REMARKS

Claims 1-33 are pending in the current application. Applicant has amended FIG. 1 as well as claims 12, 18, 30, 32, and 33 and has added claims 34-50. Reexamination and reconsideration of all of the claims are respectfully requested.

FIG. 1 (PRIOR ART)

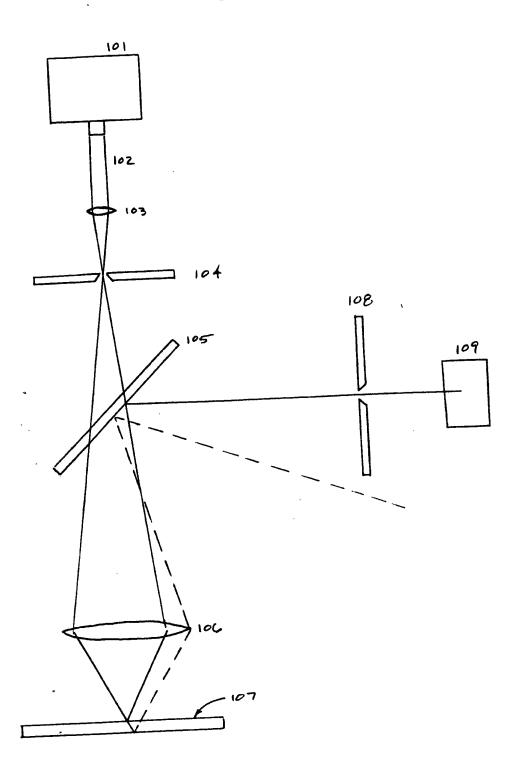
The Examiner objected to FIG. 1 as not being labeled PRIOR ART. Applicant has amended FIG. 1 to include the PRIOR ART notation in red ink, attached hereto as Exhibit A.

FIG.1 is amended in red ink as presented in Exhibit A attached hereto IN THE CLAIMS
